LEE VISTA WAREHOUSE #2 MPL

7533 LEEVISTA BLVD.

Applicant's Request: Master Plan approval to construct a speculative warehouse totaling ±294,700 sq. ft., to be located on a 21.3-acre parcel in the Airport North neighborhood. The property is zoned I-P/AN.

LANDSCAPE PLAN

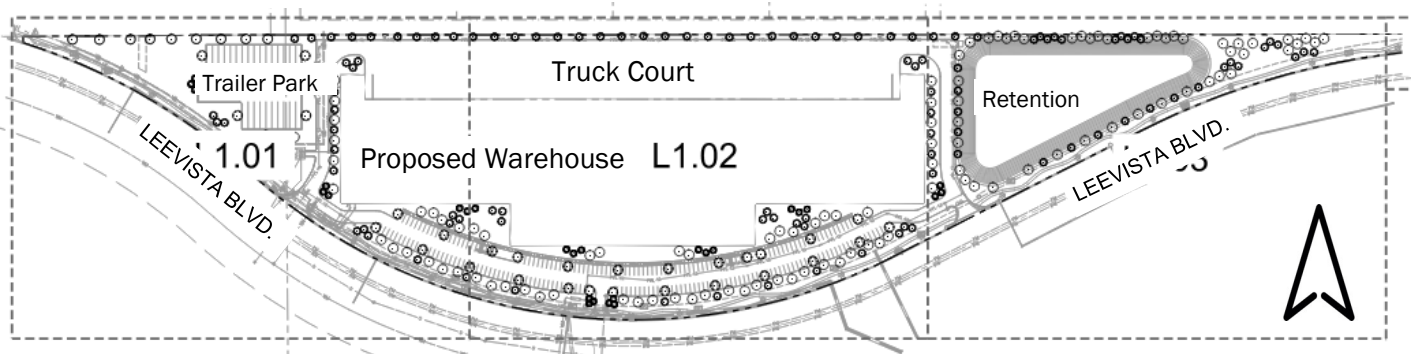
6. Street trees are required along Lee Vista Blvd. Said street trees must be canopy trees and planted per LDC Sec. 60.216. If an obstruction exists (i.e. powerlines), understory trees may be used in lieu of canopy trees.

8. All vehicular use areas must be sufficiently screened from any street. Such screening should utilize a combination of groundcovers, hedges, and understory trees. This screening is in addition to any canopy trees that are required around the perimeter of vehicular use areas and in any row-end/intermediate landscape islands.

9. All trees located around the parking lot perimeters and within all row-end and intermediate landscape islands must be canopy trees. Specific plantings must be provided at time of permitting. All parking lot landscaping must comply with LDC Sec. 61.312.

10. Loading docks must be adequately screened from potential views from Lee Vista Blvd.
11. A hedge is required around the perimeter of both the parking lots and the truck staging parking lots. The hedge must be a minimum of 3-ft tall at the time of planting and maintained at a minimum 4-ft height.

12. Trees must also be planted around the perimeter of all truck staging parking lots and the on-site stormwater detention pond at a minimum of 50 ft. on center. Required trees must be canopy trees, must have a minimum caliper of 2 in., and a minimum overall height of 12 ft.

ENLARGED SITE PLAN

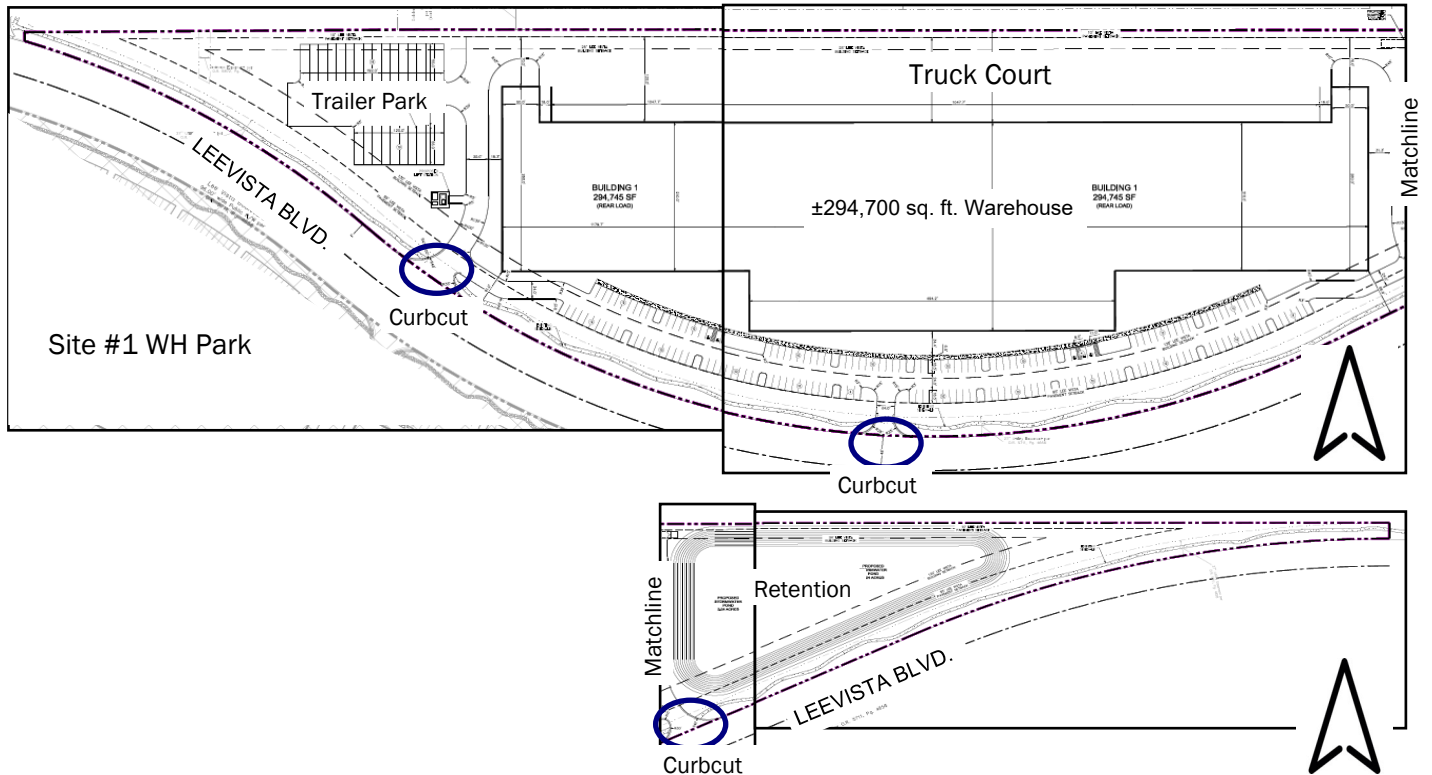
1. Drawing C-401 submitted with the Application shows an on-site private lift station with a 4-inch force main discharging to the existing City's 24-inch force main on Lee Vista Blvd. Connection to the 24-in. force main will not be allowed. The Applicant's Engineer needs to contact the WRD to schedule a meeting to discuss an alternative connection point prior to Construction Plans submittal for review.

SOUTH (Front) ELEVATION, as viewed from Leevista Blvd.

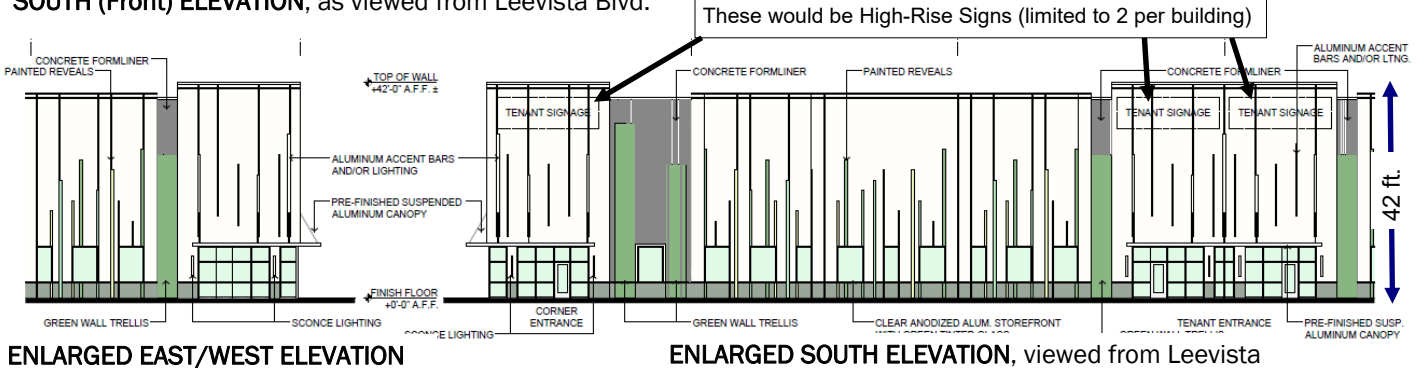
NO NORTH (Truck Court) ELEVATIONS PROVIDED

1. An Appearance Review must be completed at time of permitting to ensure all comments and conditions have been met. Color elevations (all 4-sides) and perspective images must be provided. If a final site plan determination is required, the AR review may be completed at that time.
2. Direct pedestrian connectivity from the Lee Vista Blvd public right-of-way to the building is required.

3. For industrial building facades, a base, middle, and top must be expressed, with materials, finishes, and details wrapped on all facade corners to a logical architectural end point.
4. Primary pedestrian entries must be clearly expressed and highlighted and recessed or framed by a sheltering element such as an awning, arcade, porch, portico, or canopy.
5. A minimum of 30% building transparency is required on all facades facing a public or private right-of-way or street. Warehouse buildings must contain window slats between 5 and 7-ft. from the finished floor on roll-up doors facing truck loading/unloading areas.
